ADDENDUM NO. 01

September 23, 2026

**WARREN COUNTY CAREER CENTER
MEDICAL ACADEMY ADDITION
3525 NORTH STATE ROUTE 48
LEBANON, OHIO 45036**

LPA PROJECT NO. 263306.00

SUPPLEMENTAL
SURVEY BASEMAP
C111

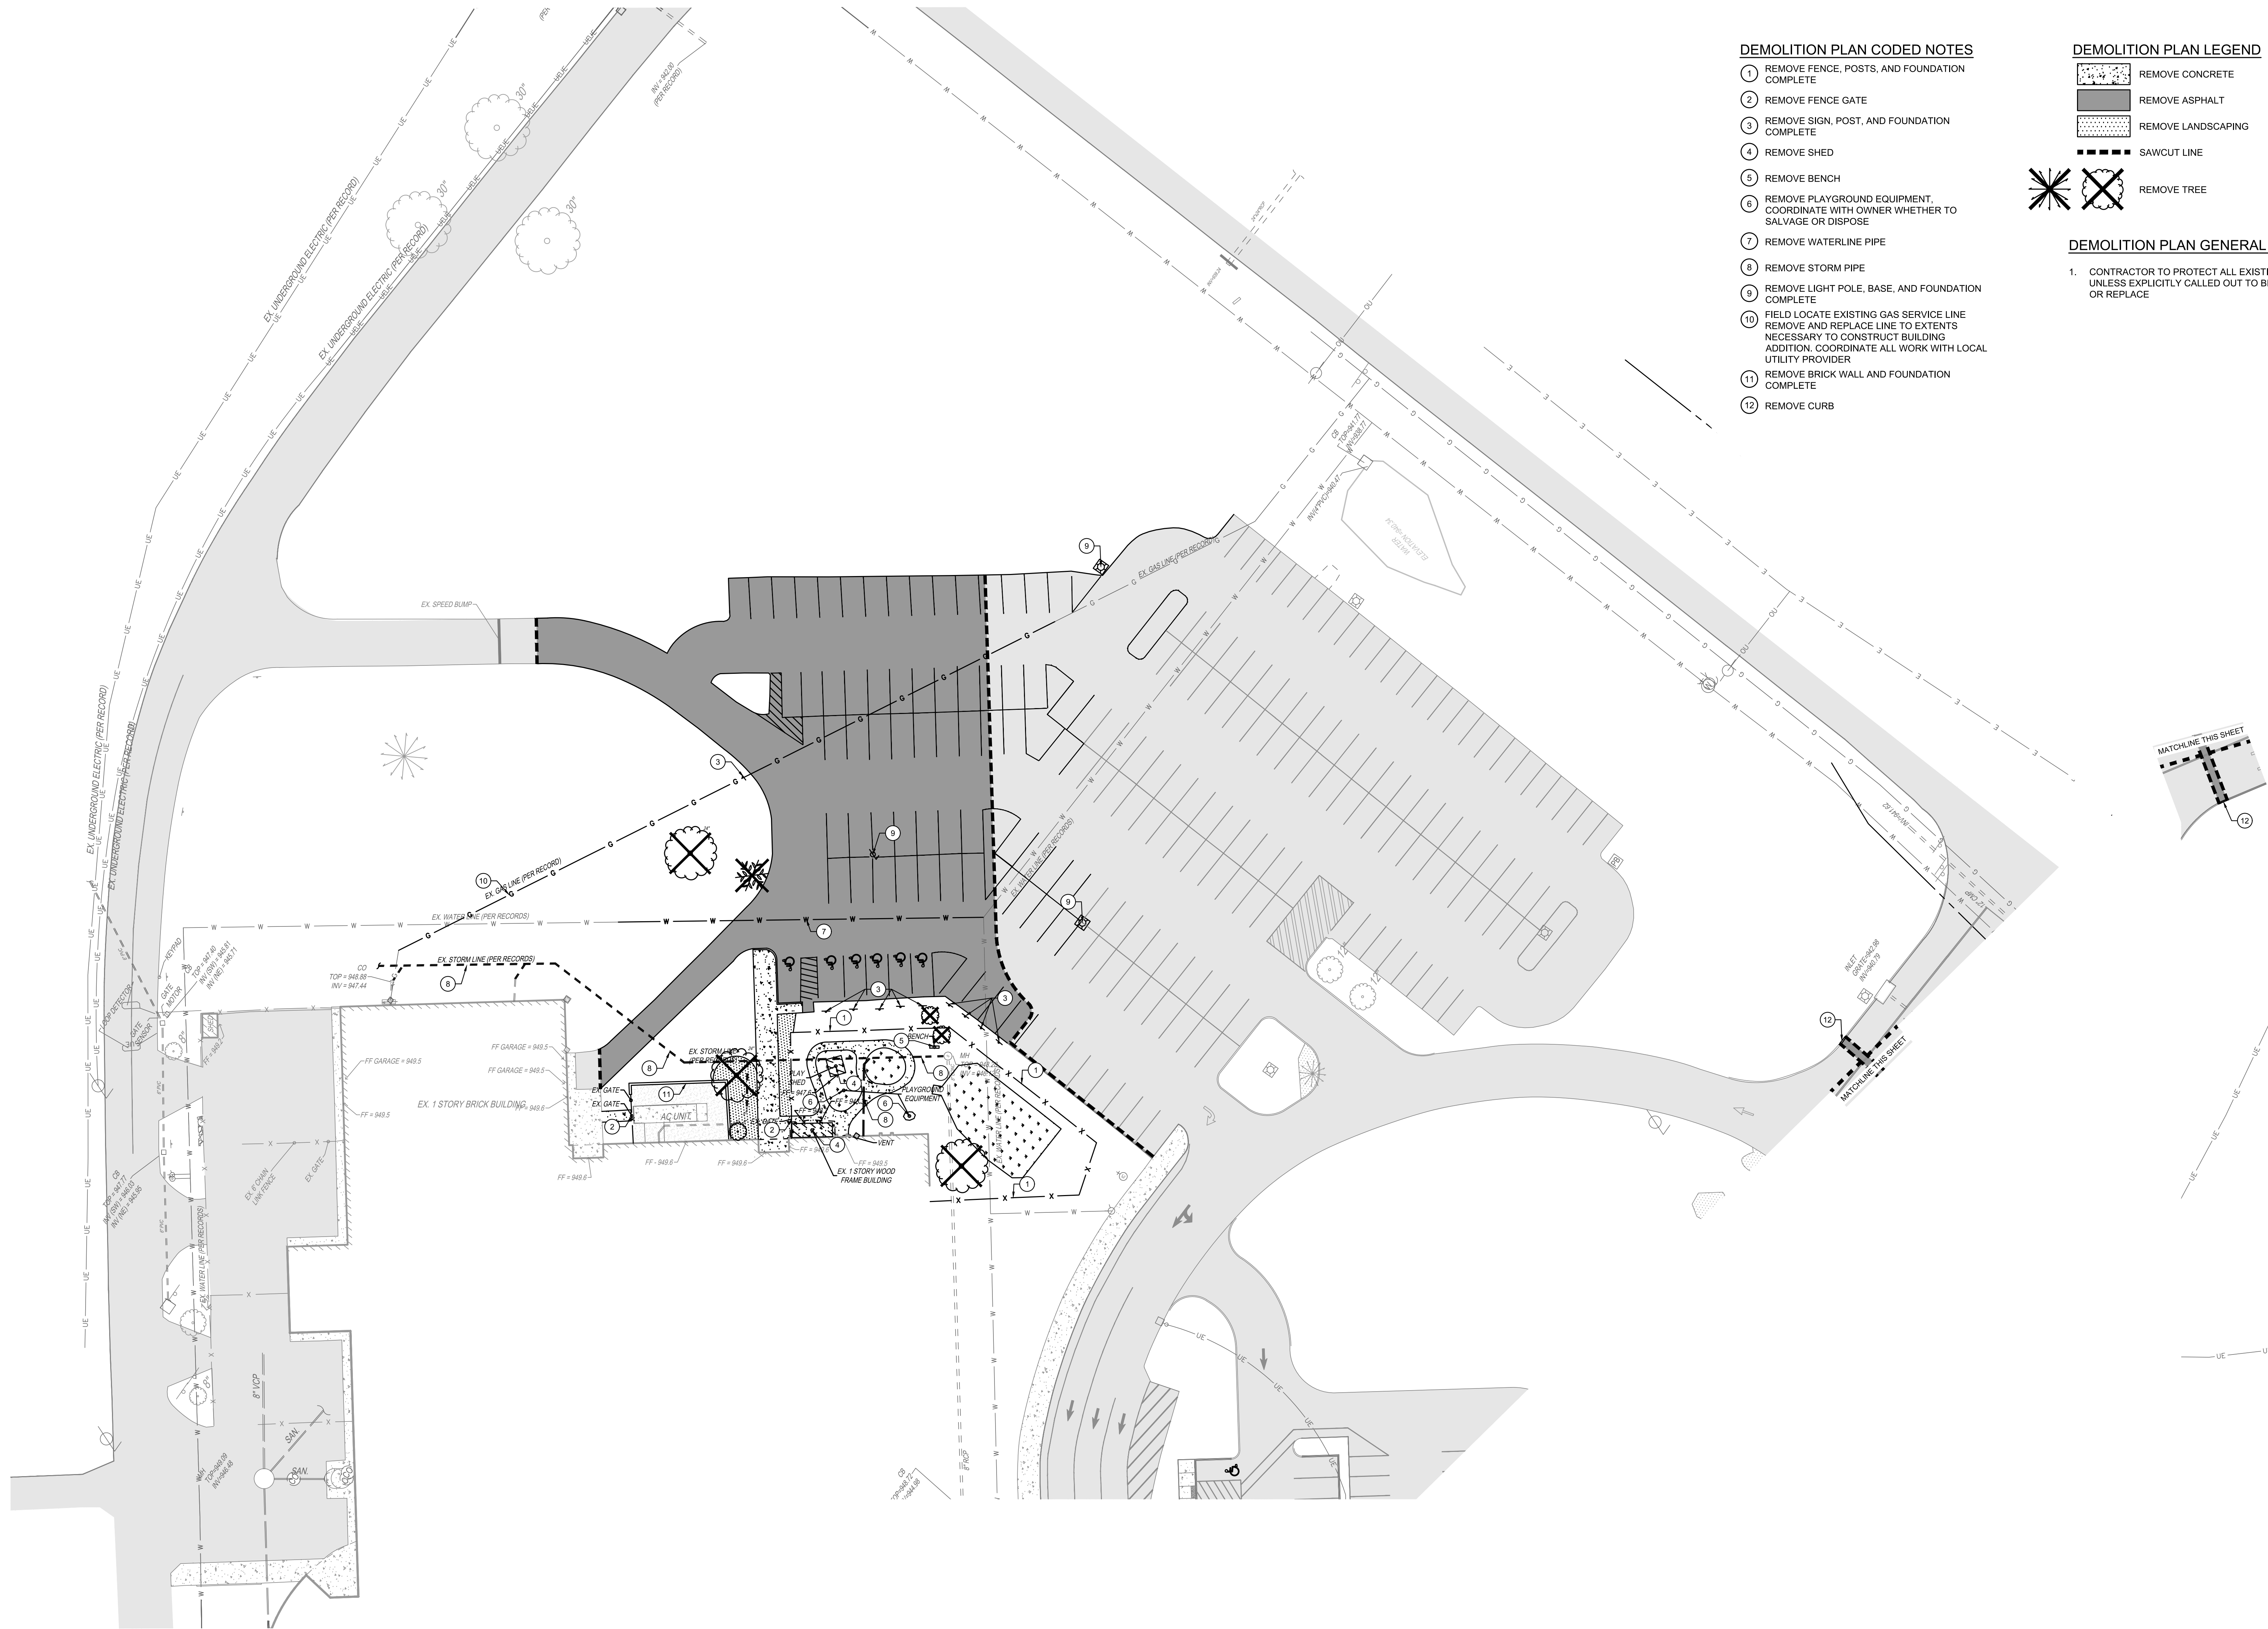
- 2.27 Sheet C100
 - Updated exterior railing type
- 2.28 Sheet C111
 - Showed existing gas and sanitary lines per private utility locate
- 2.29 Sheet C120
 - Revised extents of gas and water line demolition.
 - Removed asphalt necessary for sanitary force main installation.
- 2.30 Sheet C130
 - Updated playground to match current LA plans including fencing, curbing, and ground cover
 - Replaced asphalt necessary for sanitary force main installation
- 2.31 Sheet C140
 - Revised extents/routing of proposed gas and water lines.
 - Installed new manhole just north of addition to help with sanitary / storm intersection
 - Revised underdrain route per new playground.
- 2.32 Sheet C141
 - Added utility crossings to profiles.
 - Revised storm lines to avoid conflict with proposed sanitary pipe
- 2.33 Sheet C150
 - Revised grading to match new playground
